CAMBRIA
Environmental Technology, Inc.

February 6, 1996

Re: **Work Plan Addendum**
15595 Washington Avenue
San Lorenzo, California

FIGURE
1

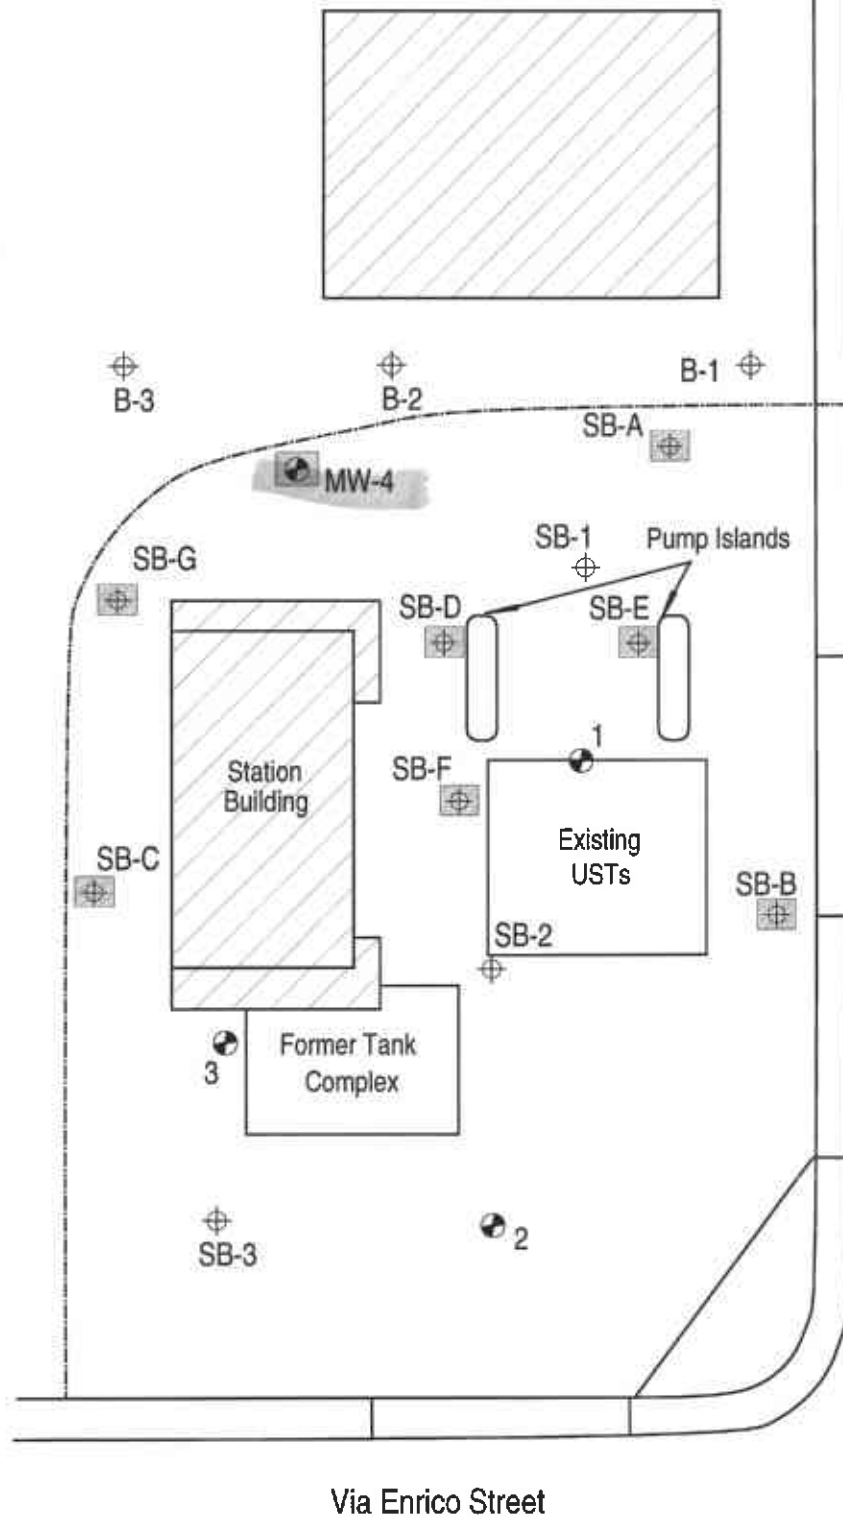
As you discussed in your February 6, 1996 conversation with Joseph Theisen, this addendum revises certain aspects of Cambria's upcoming site assessment at the site referenced above. Cambria will drill seven soil borings to about 12 ft depth and one soil boring to 25 ft, converting the 25 ft soil boring to a ground water monitoring well. This configuration eliminates one ground water monitoring well (MW-5), replacing it with a boring (SB-G), and relocates MW-4 and SB-A further west. The new configuration is shown in Figure 1.
